**SUBJECT: WATERFORD STEAM ELECTRIC STATION, UNIT 3 – NRC INTEGRATED
INSPECTION REPORT 05000382/2015001 AND FINAL SIGNIFICANCE
DETERMINATION OF GREEN FINDING NRC INSPECTION
REPORT 05000382/2015009**

Report: 05000382/2015001

Facility: Waterford Steam Electric Station, Unit 3

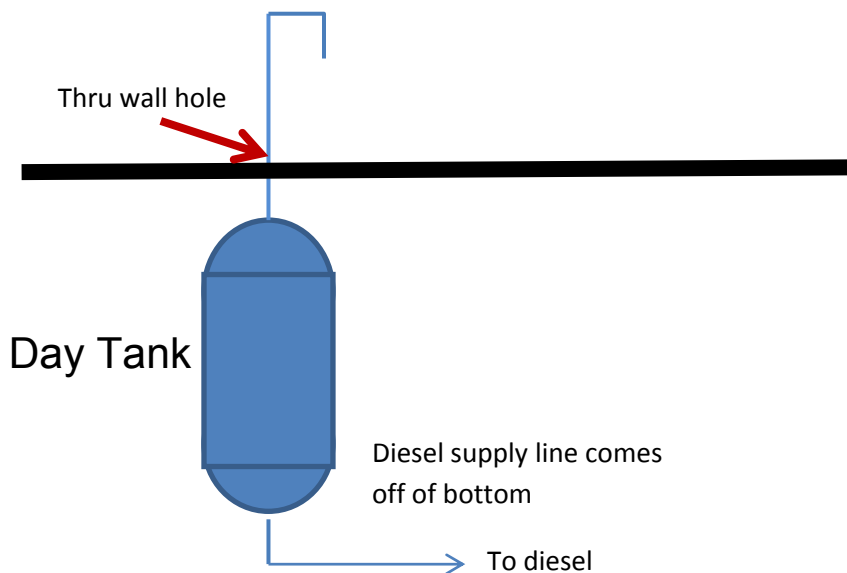
To address the tolerance of the diesel generator to water in the fuel oil stream, the licensee demonstrated that the Waterford-3 emergency diesel generators could process a 7 gallon slug of water without failing and the diesel generators were tolerant of a steady stream of water up to 40 gallons per hour. The "trickle" test of 40 gallons per hour bounded the scenarios that included a heavy rain event with a coincidental loss of offsite power (Scenario 2).

Concerning the water testing on the diesel generator day tank roof, the licensee had applied a flow stream of 20 gallons per minute of water onto the roof. This corresponded to a 5 inch/hour rainfall event. While analytical methods had predicted that the water level at the A vent (the higher vent) should reach approximately ½ inch (compared to the local roof level), the actual

water level fell short of reaching the vent. Therefore, the licensee's analytical methods appeared overly-conservative. The revised detailed risk evaluation was adjusted to account for these test results.
